Contract #: **04-0120E4**  
 Cty **SF** Rte **80** PM **13.4/13.8**  
 File # **45.25 B**

## QUALITY ASSURANCE - NONCONFORMANCE REPORT

Subject: Response to Submittal No. 1126, Revision No. 00 (KOS Response to NCR 119 (SL-1966))

KFM SUBMITTAL 1126-00 –KIEWIT OFFSHORE SERVICES (KOS) RESPONSE TO NONCONFORMANCE REPORTS 119

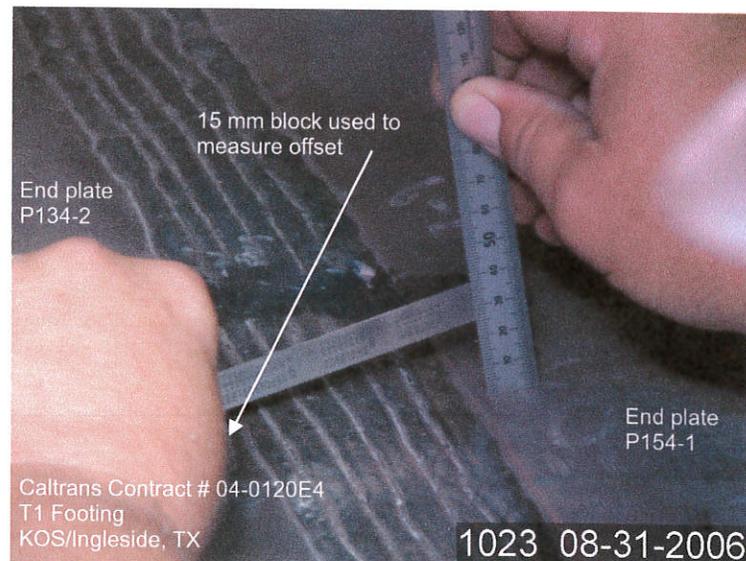
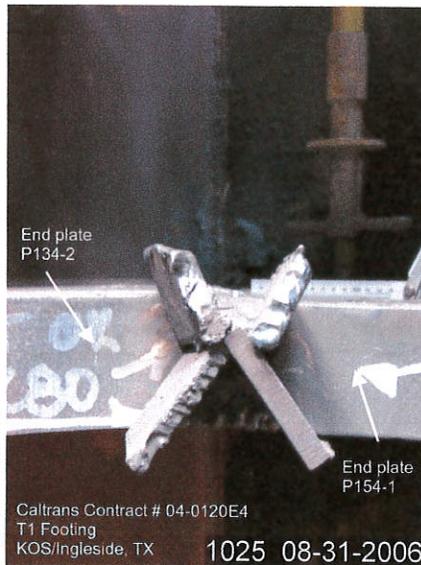
**Description of Non-Conformance:** KOS Quality Control has allowed the welding of a complete joint penetration weld joining end plates P154-1 and P134-2 with an offset (misalignment) varying between approximately seven and ten millimeters. The misalignment is outside the tolerances set in AWS D1.5-2002, Section 3.3.3.

**Contractor's proposal to correct the problem:** The Contractor has stated they will submit an RFI detailing their proposal to correct the misalignment.

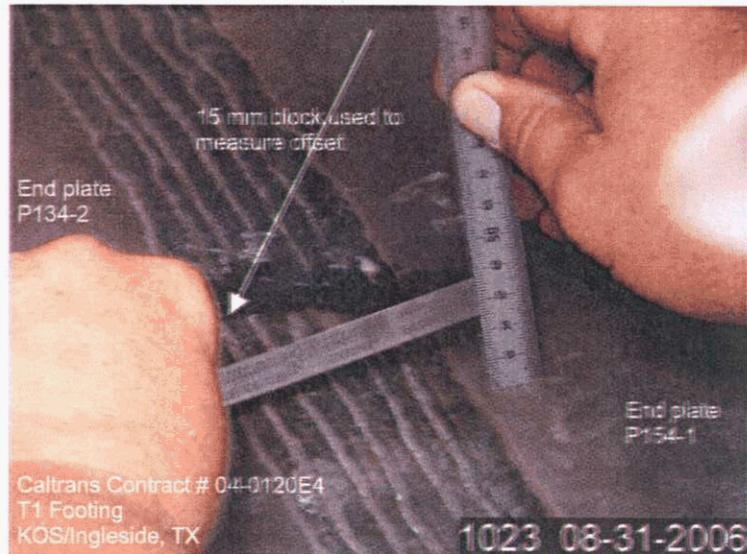
**Description of Non-Conformance:** KOS Quality Control has allowed the welding of a complete joint penetration weld joining end plates P154-1 and P134-2 with an offset (misalignment) varying between approximately seven and ten millimeters. The misalignment is outside the tolerances set in AWS D1.5-2002, Section 3.3.3.

**Contractor's proposal to correct the problem:** The Contractor has stated they will submit an RFI detailing their proposal to correct the misalignment.
